CERTIFICATE OF APPROPRIATENESS

**RE: Application Number 20-6986; 2467 Cass; Cass-Henry Historic District
Project Scope: Rehabilitate Apartment Building**

RE: 2467 Cass Avenue—Atlanta Apartments

Sheet
6A101

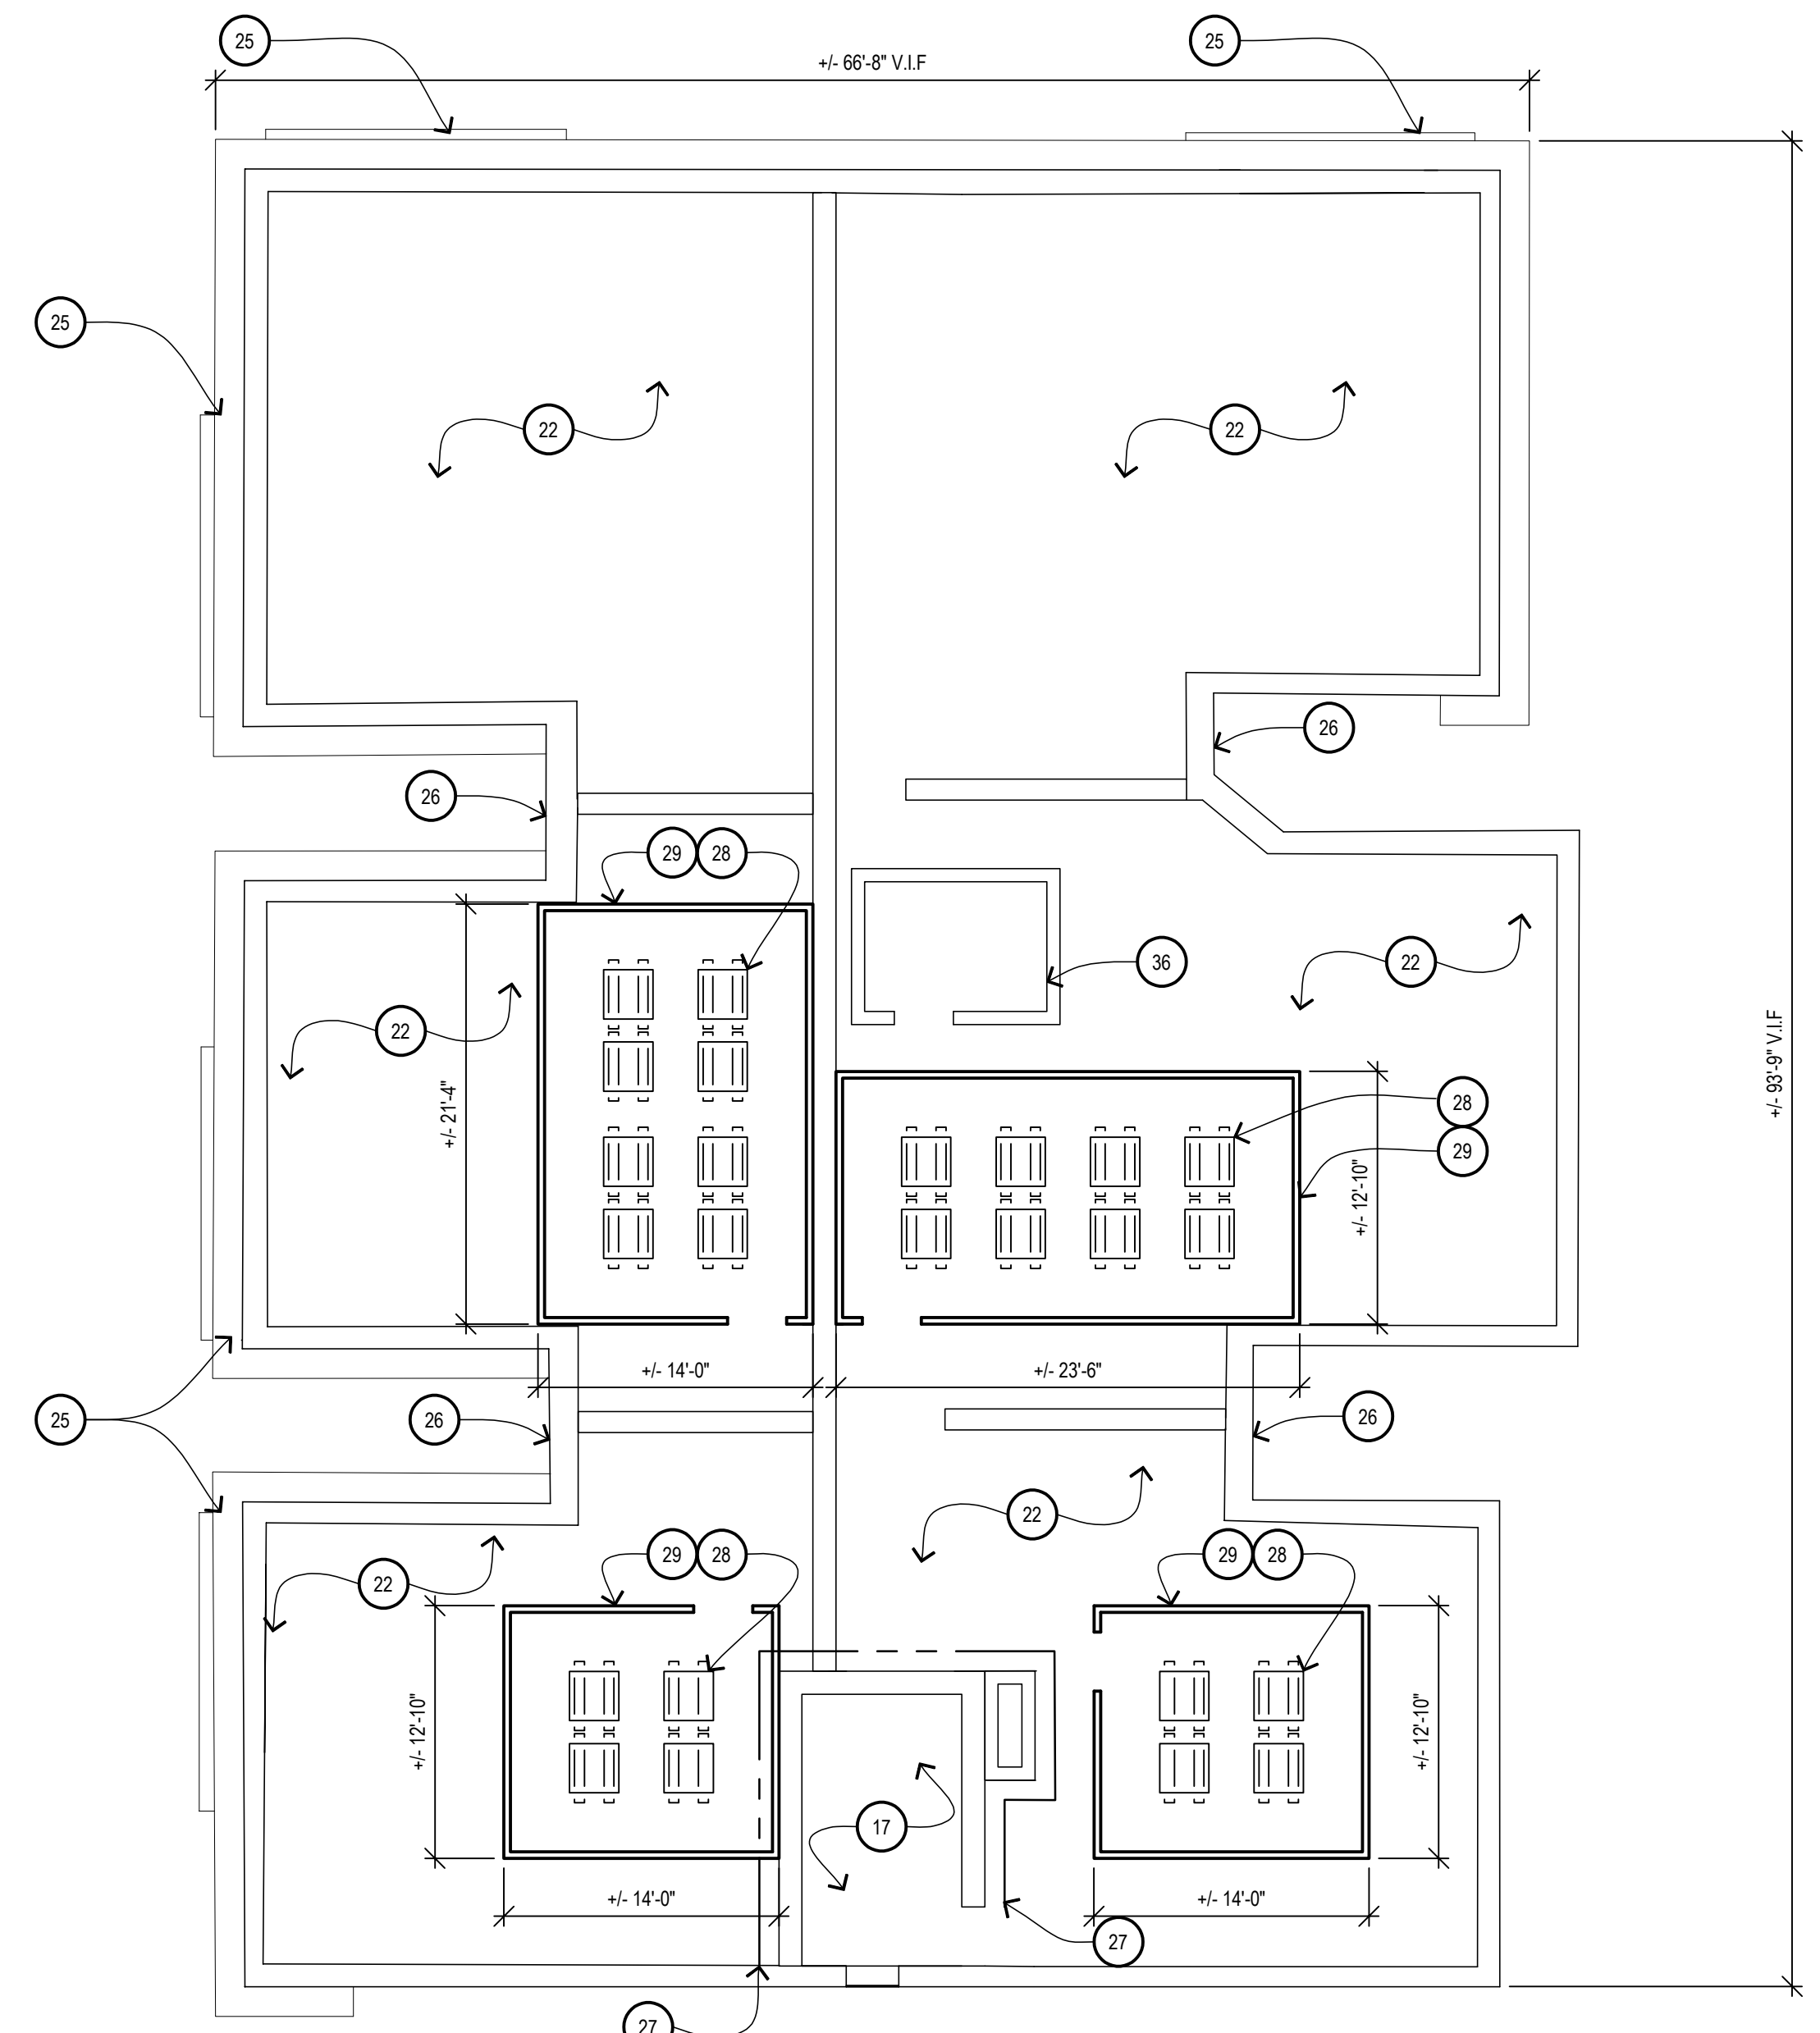
And, as per the submitted documents, specifically drawings 6A101, 6A102 (floor/roof plans) and 6A401, 6A401.1 (elevations).

The Certificate of Appropriateness is issued with the following conditions:

- Staff review of the submitted construction drawings will include the identification of specific standards concerning repair and/or replacement of deteriorated character-defining features, and related standards concerning the qualifications of historic preservation contractors retained to perform the work.

- Staff review of the submitted construction drawings to specifically include review of specifications/cut sheets for lighting, windows, doors, ADA lifts, signage, paint removal, paint color, and other exterior elements/selections not yet finalized, with staff authority to approve if per the Secretary of the Interior's Standards, the district's Elements of Design, and otherwise consistent with Commission intent and guidelines.

- The proposed design for 8/1 and 6/1 windows may be replaced by 1/1 windows at the architect's discretion, subject to staff review.
- The historic name of the building, set in stone above the entryway, be preserved and remain visible.
